**TRANSWESTERN PIPELINE**  
An ENERGY TRANSFER Company

**RE: Response to Approval Letter Comments**  
2017 Annual Report  
Roswell Compressor Station No. 9  
Transwestern Pipeline Company  
Roswell, Chaves County, New Mexico  
NMOCD Case #GW-052  
EPA ID No. NMD986676955  
HWB-TWP-17-002

DRAWN: HVP	CHECKED: SD	DATE: 7/25/18	FIGURE: 1-3
------------	-------------	---------------	-------------

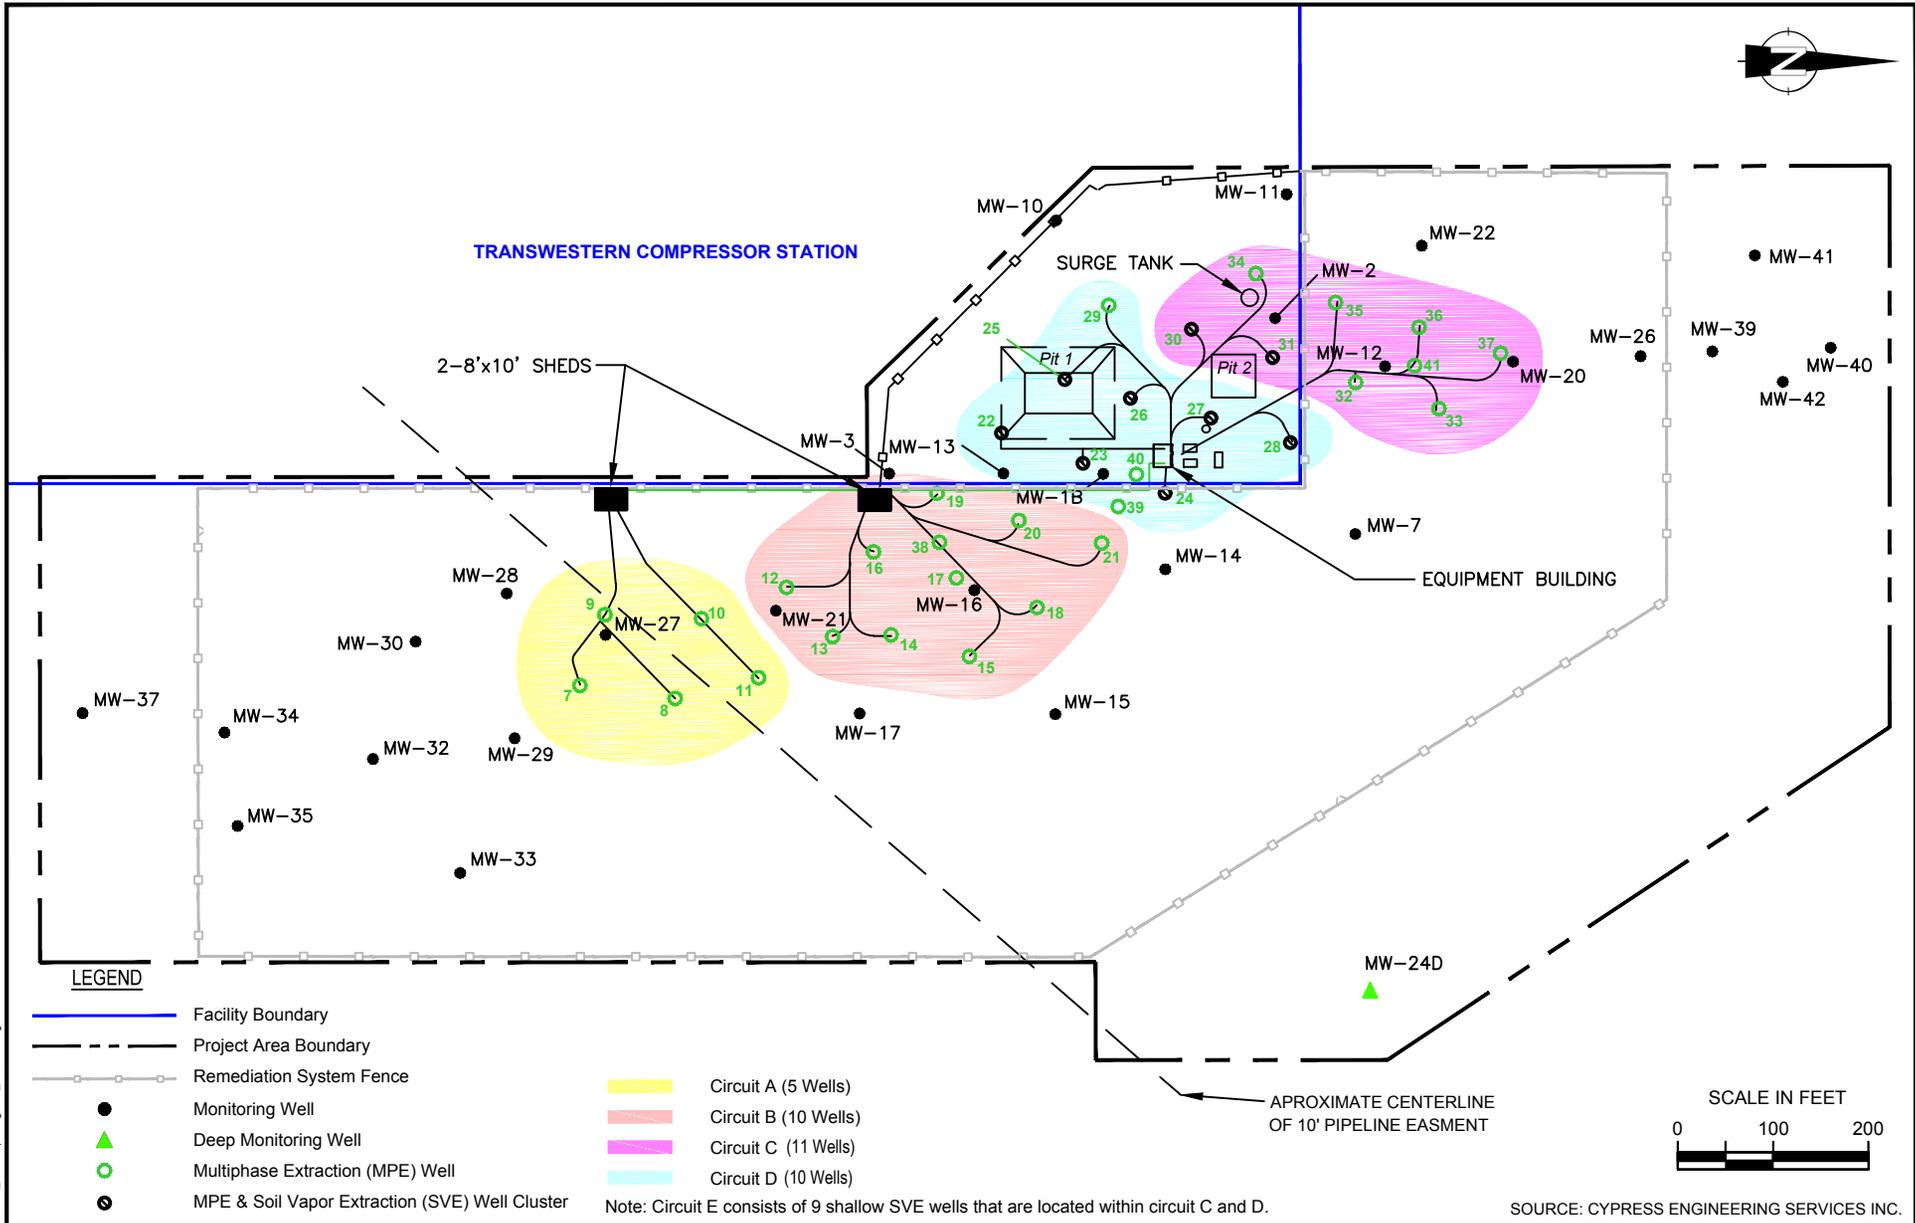
In Section 5.0, *Soil Vapor Extraction Optimization Pilot Study*, page 10, the Respondent states, “in Circuit B, eleven recovery wells were used during the study. PID readings of greater than 150 ppmV were observed in seven of the eleven recovery wells (MPE-12, MPE-13, MPE-14, MPE-16, MPE-17, MPE-19, and MPE-20), while PID readings of less than 150 ppmV were observed in MPE-15, MPE-18, and MPE-38.” According to Figure 1-3, *Remediation System Layout*, MPE-21 is included in Circuit B; however, the PID reading from MPE-21 was not discussed. Similarly, the Respondent states, “in Circuit C, eleven recovery wells were used during the study. PID readings of greater than 150 ppmV were observed in six of the eleven recovery wells (MPE-30, PME-31, MPE-32, MPE-35, MPE-39, and MPE-40), while PID readings of less than 150 ppmV were observed in MPE-34, MPE-36, and MPE-37.” According to Figure 1-3, MPE-39 and MPE-40 are not included in Circuit C while MPE-41 is included

in Circuit C. The total number of recovery wells depicted in Circuit C is nine rather than eleven. Further, the Respondent states, “in Circuit D, nine recovery wells were used during the study. PID readings of greater than 200 ppmV were observed in each of the nine recovery wells (MPE- 22, MPE-23, MPE-24, MPE-25, MPE-26, MPE-27, MPE-28, MPE-29, and MPE-41).” According to Figure 1-3, MPE-41 is not included in Circuit D while MPE-39 and MPE-40 are included in Circuit D. The total number of recovery wells depicted in Circuit D is ten rather than nine. Clarify the discrepancies in the response letter and provide replacement pages and a revised figure that corrects the discrepancies.

**Attachment A** contains the replacement pages regarding Comment 6. To clarify these comments, MPE-21 was not included in the test, but the well exhibited less than 150 parts per million vapor (ppmv) during initial testing. Additionally, MPE-39 and MPE-40 are in Circuit D.

WELL LOCATIONS			
DRAWN: HVP	CHECKED: RLA	DATE: 03/02/2018	FIGURE: 3-1

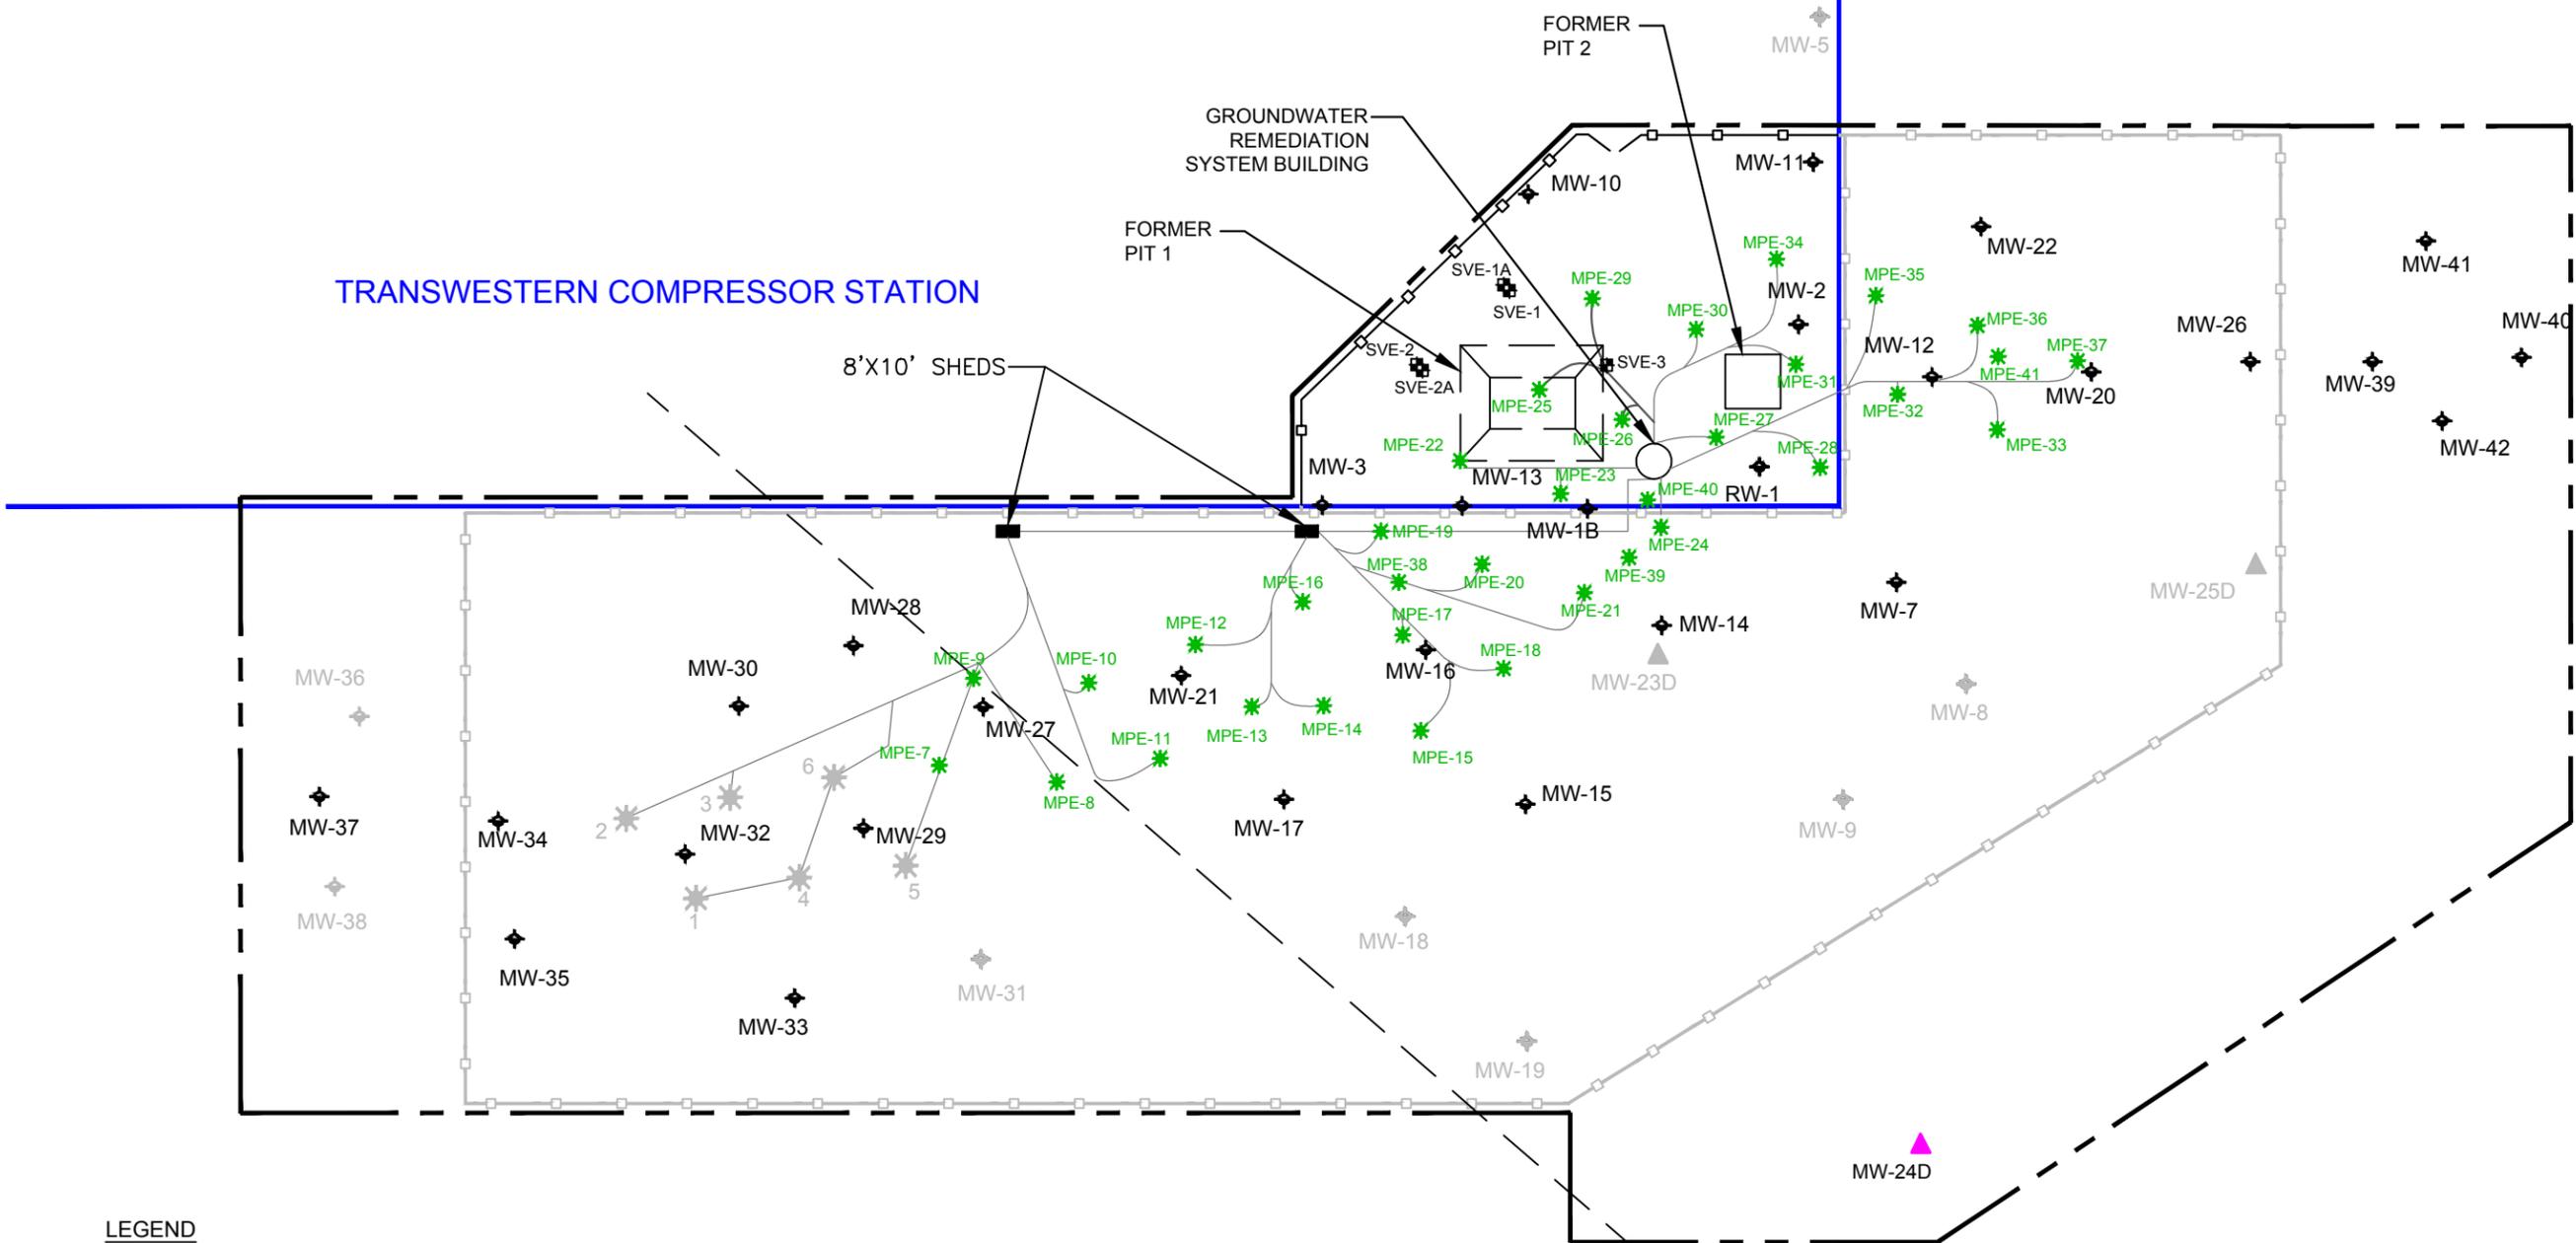
Figure 3-1, *Well Locations* does not depict the locations of the SVE wells. Provide a replacement page of a revised Figure 3-1 or a separate figure showing the locations of SVE wells. In addition, wells SVE-1A, SVE-2A and SVE-3 appear to be active according to Table 3-4, *Summary of Well Completion Details*. However, these SVE wells are not listed in Table 3-2, *Summary of Groundwater Surface Elevations*. Include these SVE wells in Table 3-2 and provide a replacement page. If these SVE wells have not been gauged previously, resume the measurements starting in 2018. The data must be presented in future reports.

**Attachment B** contains the revised Figure 3-1. Water levels were not collected from wells SVE-1A, SVE-2A and SVE-3 and were therefore not included in Table 3-2. These wells will be added to the Fall 2018 well gauging.

DRAWN: HVP	CHECKED: RLA	DATE: 03/18	FIGURE: 3-4
------------	--------------	-------------	-------------

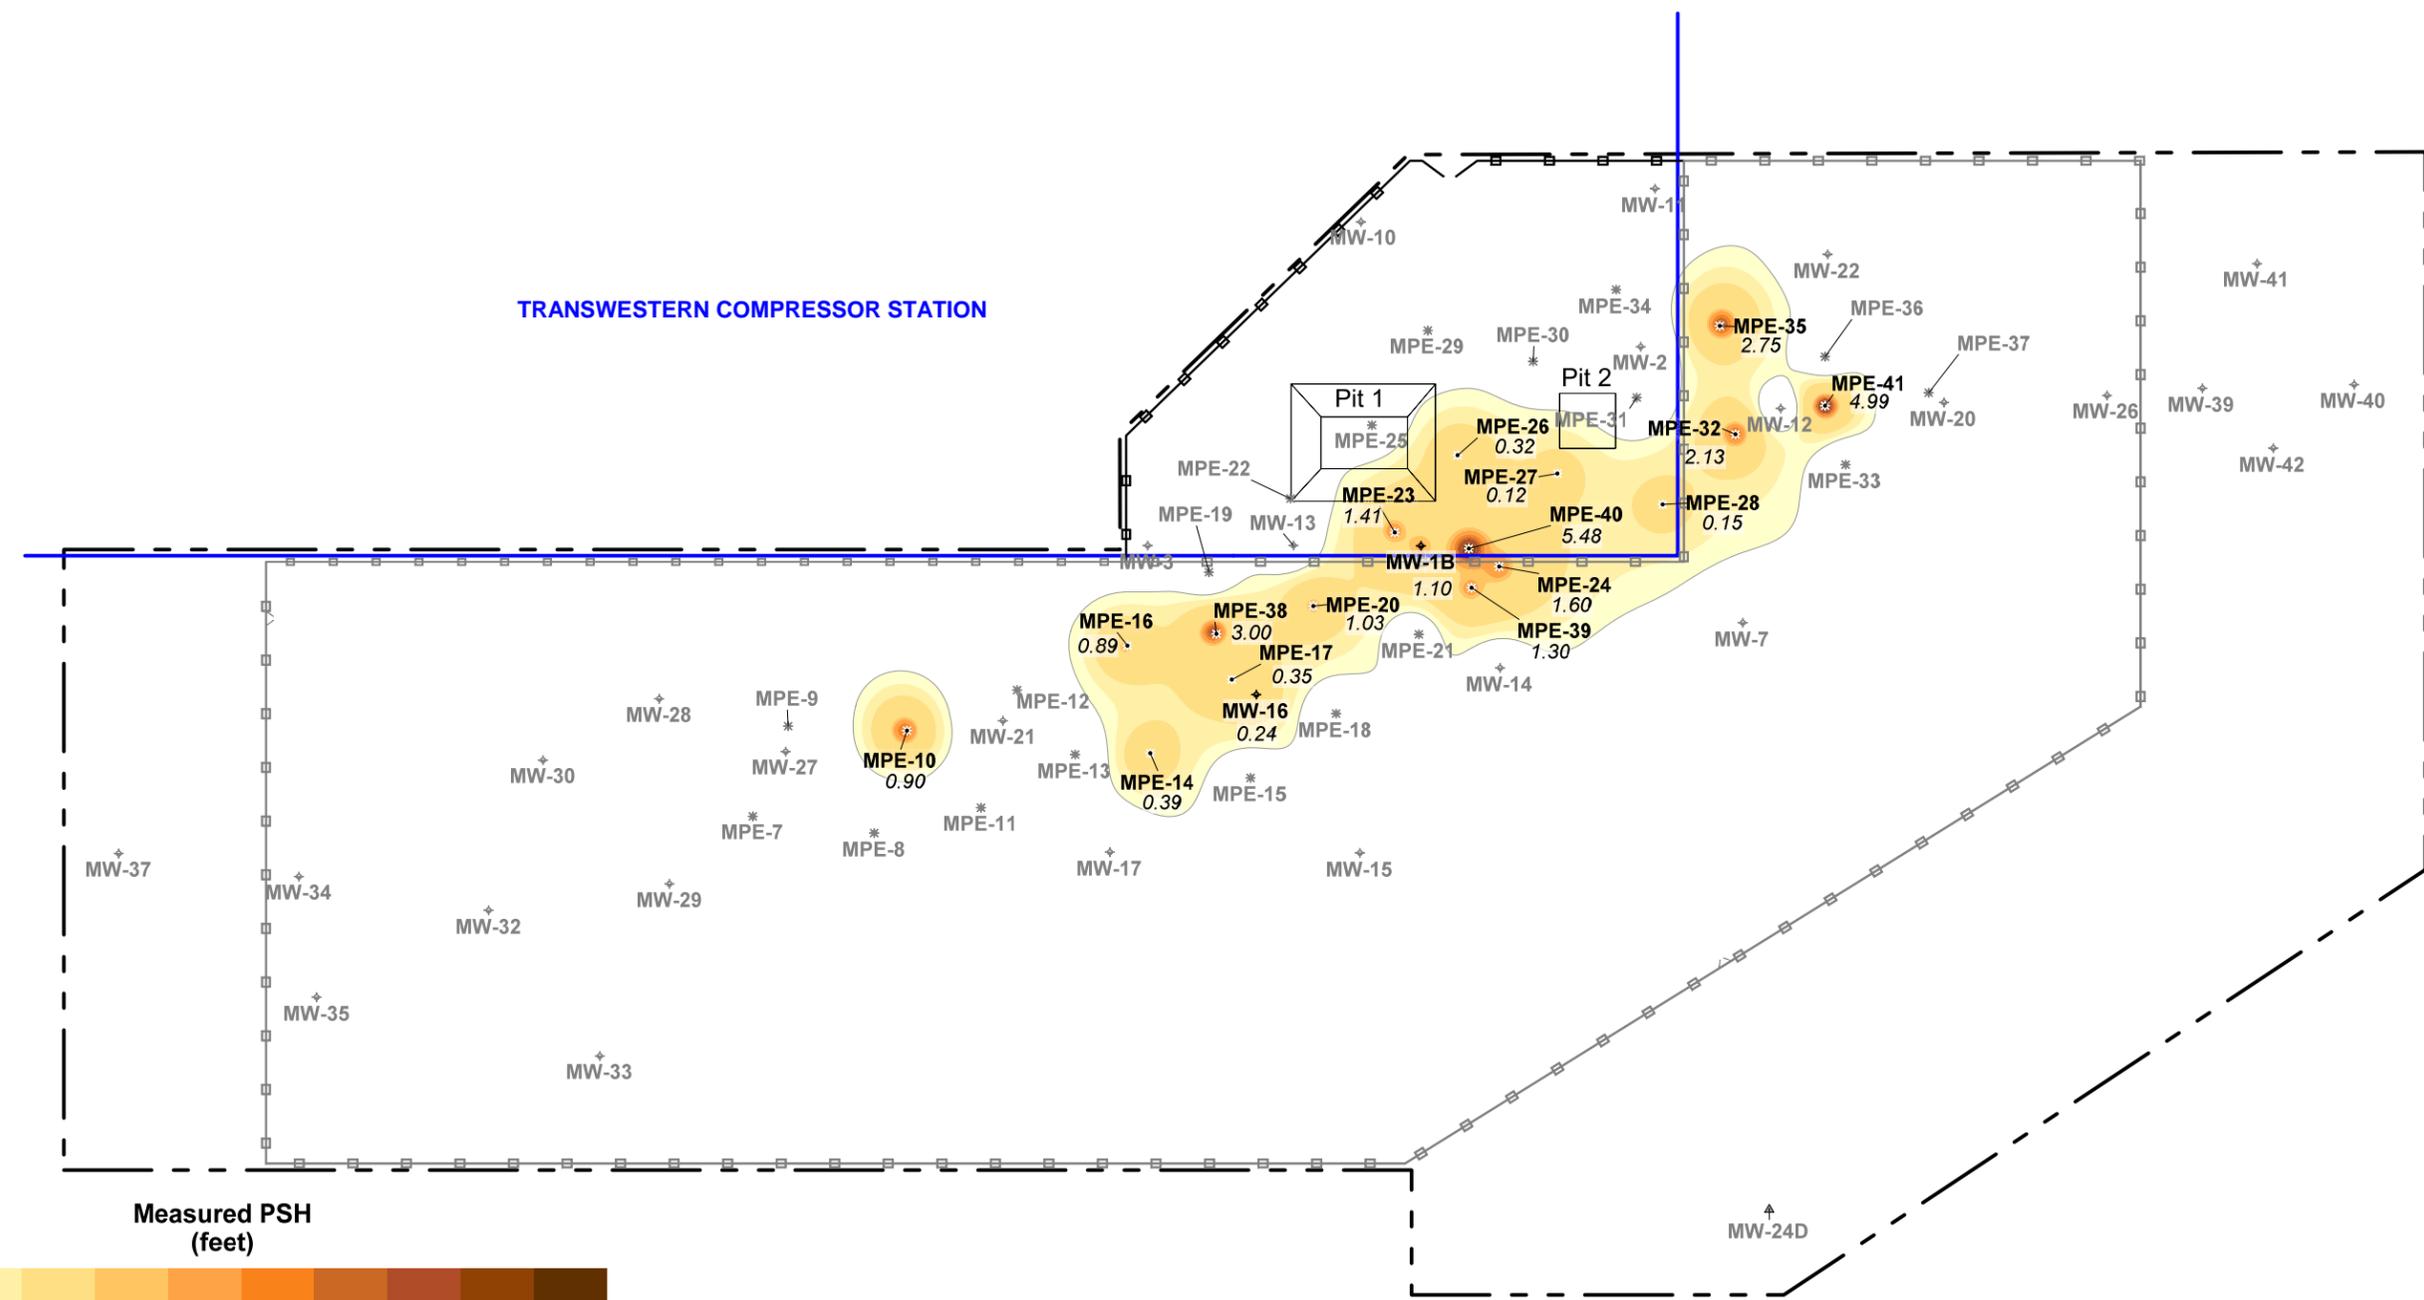
Figures 3-4 and 3-5 use color scale to depict a thickness contour for measured phase separated hydrocarbons (PSH). The thickness of PSH and the color that represents its thickness do not match in the figures. For example, the thickness of PSH in well MPE-10 is recorded as 0.90 feet in Figure 3-4; however, the color representing its thickness depicts more than one foot. The thickness of PSH in well MPE-10 is recorded as 1.01 feet in Figure 3-5; however, the color representing its thickness depicts less than one foot. Revise Figure 3-4 and Figure 3-5 to present accurate PSH thickness. Provide replacement pages for the figures in the response letter.

**Attachment C** contains the revised Figures 3-4 and 3-5.
